SERVICE BULLETIN

COCKPIT AND CABIN DOOR HOUSING REPLACEMENT

McDonnell Douglas Helicopter Systems (MDHS) MD900 Series Helicopters, serial numbers 00008 thru 00058.

Figure 1. Cockpit Door Mechanism

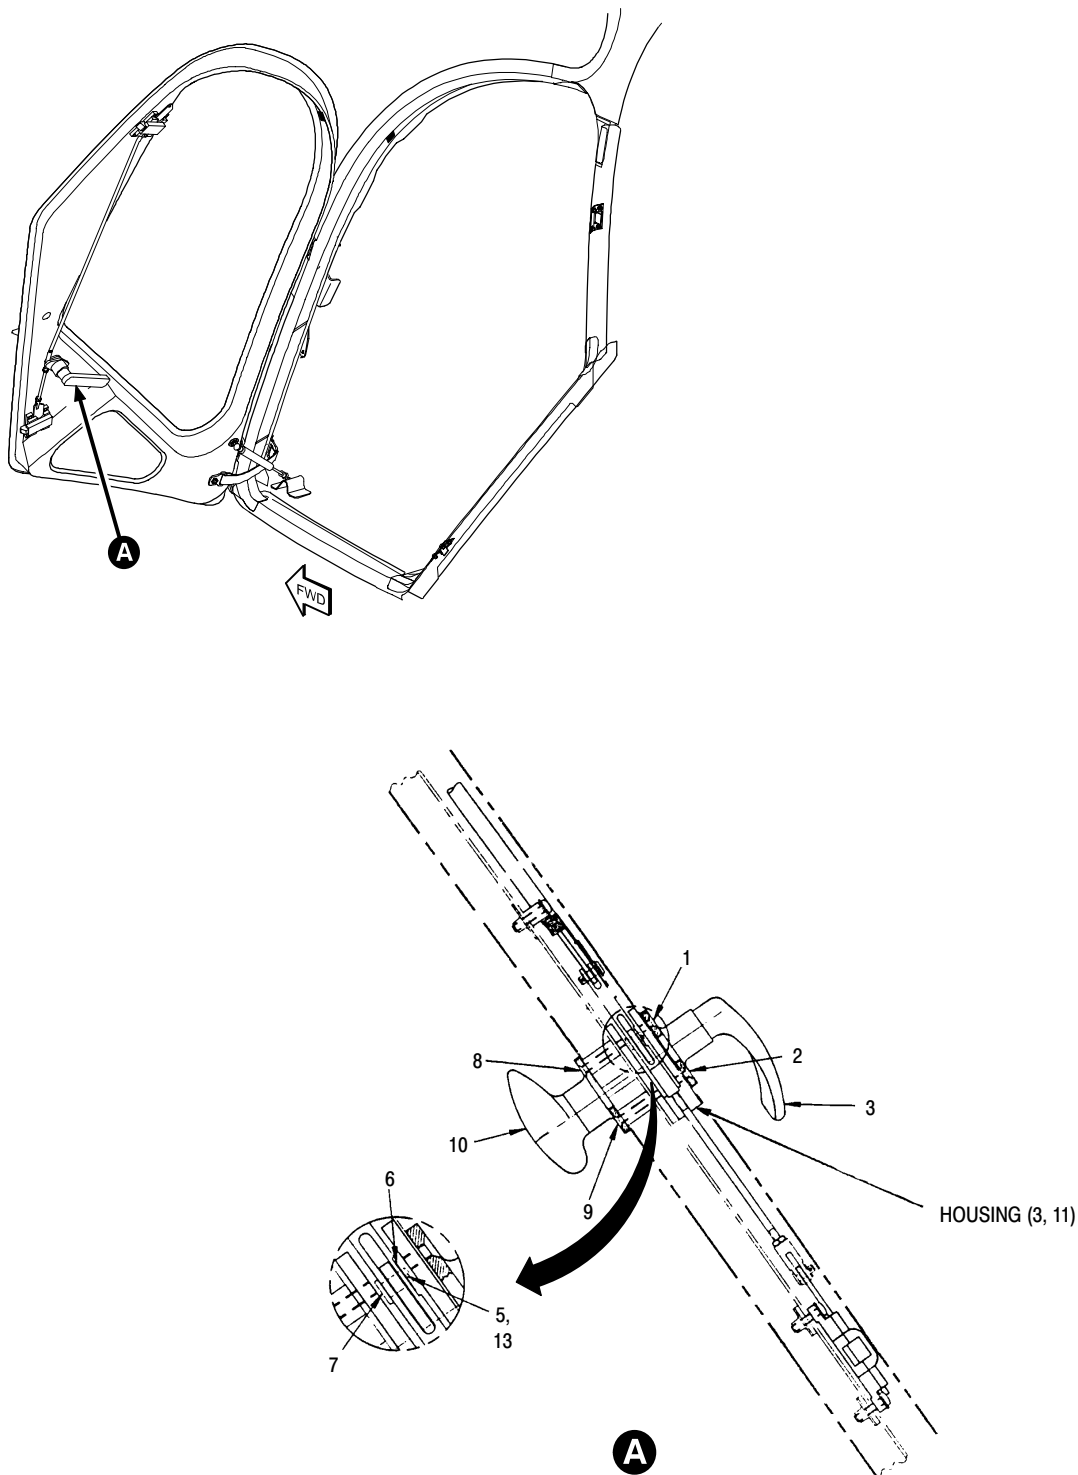
Operators have reported two malfunctions with the pin/cam assembly, within the cockpit and cabin door mechanism housing assembly. The pin has separated from the cam in both cases, rendering the inside door handle inoperable. Failure to comply with the requirements of this Bulletin may result in malfunction of the door latching mechanism. This condition will not allow the doors to be opened from inside the cockpit or cabin. NOTE: The cockpit and cabin door emergency egress feature will still be available.

A. PART 1. Cockpit Door Mechanism (Refer to Figure 1)

- (1). Turn both the inside and outside handles to the **SAFELOCK** position.
- (2). Remove screws (1) & (2) and interior handle (3). Note position of screws (1) & (2) for later reinstallation.

- (3). Remove interior trim panel.
- (4). Remove cotter pin (5) and discard. Remove and retain washer (6) and clevis pin (7).
- (5). Remove housing 68606-3/-4 by removing screws (8) & (9) and exterior handle (10). Note position of screws (8) & (9) for later reinstallation.

- (6). Install modified housing (11) & (12) using screws (8) & (9) and exterior handle (10). Ensure exterior handle lines up with the **SAFELOCK** position on the exterior decal. Reattach housing to mechanism using washer (6) and clevis pin (7). Install new cotter pin (13).

- (7). Reinstall interior trim panel (4).
- (8). Reinstall interior handle (3) using screws (1) & (2). Ensure interior handle is in the **SAFELOCK** position.

- (9). Check operation of the door mechanism per CSP-900RMM-2, Section 52-00-00, page 603, step B.

Figure 2. Cabin Door Mechanism

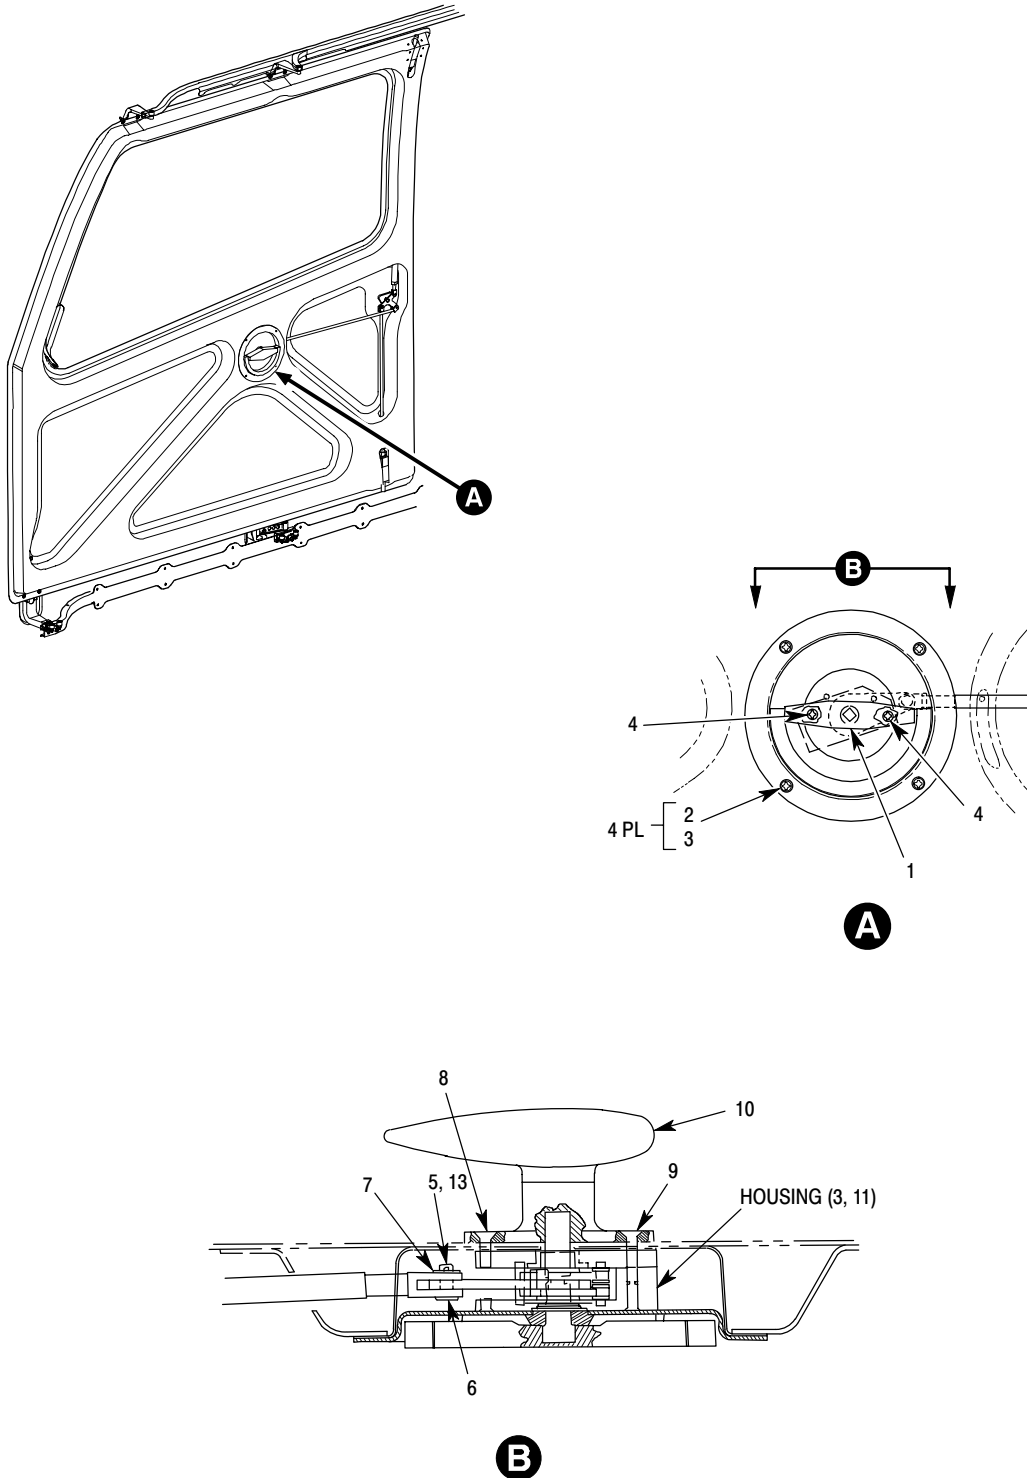
B. PART 2. Cabin Door Mechanism (Refer to Figure 2)

- (1). Turn both the outside and inside handles to the **SAFELOCK** position.
- (2). Remove D-Ring (1) from the cabin door by removing four screws and washers (2) & (3) and two screws (4). Retain screws and washers for reinstallation.

- (3). Remove cotter pin (5) and discard. Remove and retain clevis pin (6) and washer (7).
- (4). Remove housing 68623-1/2 by removing screws (8) & (9) and exterior handle (10). Note position of screws (8) & (9) for later reinstallation.

- (5). Install modified housing (11) & (12) using screws (8) & (9) and exterior handle (10). Ensure exterior handle lines up with the **SAFELOCK** position on the exterior decal. Reattach housing to mechanism using washer (7) and clevis pin (6). Install new cotter pin (13).

- (6). Reinstall D-Ring (1) using screws (2) & (4) and washers (3). Ensure D-Ring is in the **SAFELOCK** position.
- (7). Check operation of the door mechanism per CSP-900RMM-2, Section 52-00-00, page 603, step C.
